Ministerial **Appeals Committee**
Environmental Protection Act 1986

Appeals Committee's Report to the Minister for Environment

Appeals against Environmental Protection Authority Report
1727: North West Shelf Project Extension

Appellants	See Appendix 1
Proponent	Woodside Energy Limited
Authority	Environmental Protection Authority
Appeal No.	24 of 2022
Date	September 2024

Figure 3 Revised operating emissions baselines and GHGe reduction trajectory (WEL 2024b)

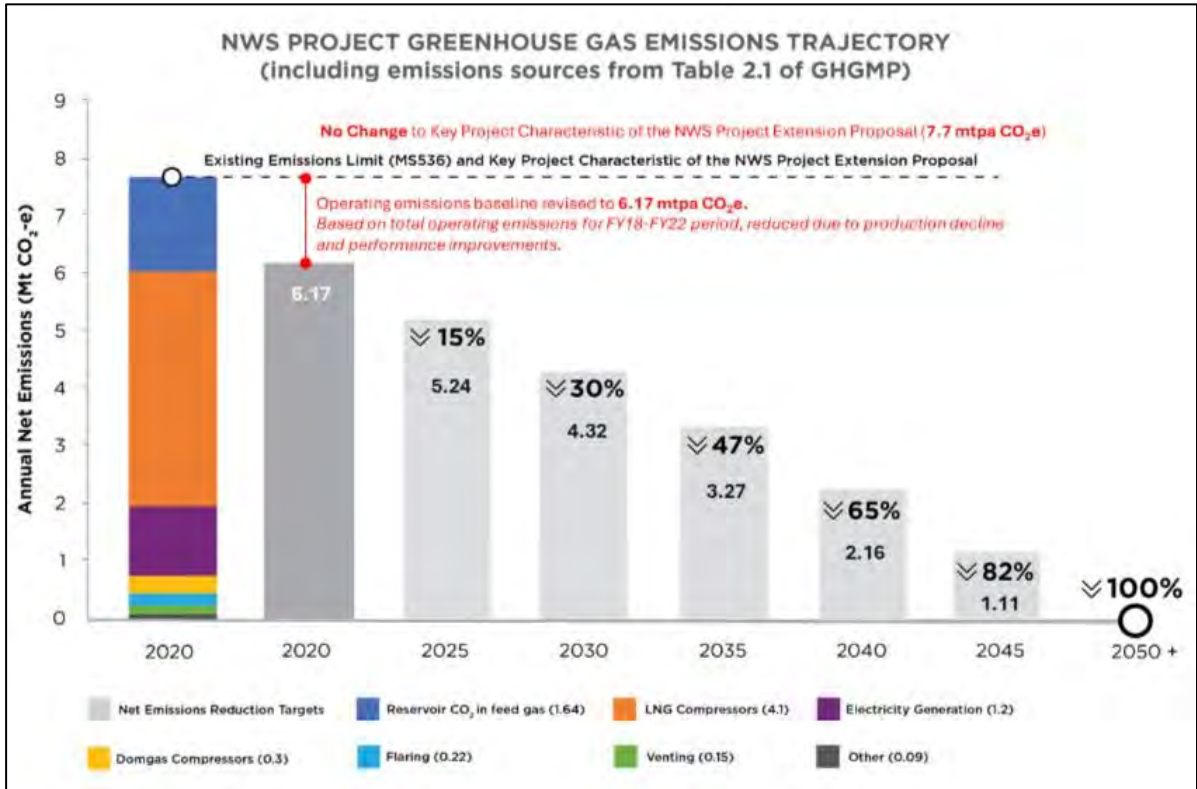
For the next revision of the GHGMP, Woodside would propose adjusting the current emissions reduction baseline from 7.7 Mt to the past 5-year operating baseline of 6.17 Mt. The associated emissions reduction commitments would also appropriately be revised for this new baseline.

The Proponent provided five-yearly operating emissions baselines for the entire emissions reduction trajectory to net zero GHGe by 2050, as represented in Figure 3 (WEL 2024b).

The Committee notes that the Proponent, without changing the Proposal, has provided operating emissions baselines for the GHGe reduction trajectory to net zero by 2050, which are reflected in the revised condition 2-3. The revised reduction trajectory would reduce the estimated maximum scope 1 GHGe over the 50-year lifetime of the Proposal from 138.85 Mt of CO₂-e to 111.35 Mt of CO₂-e.
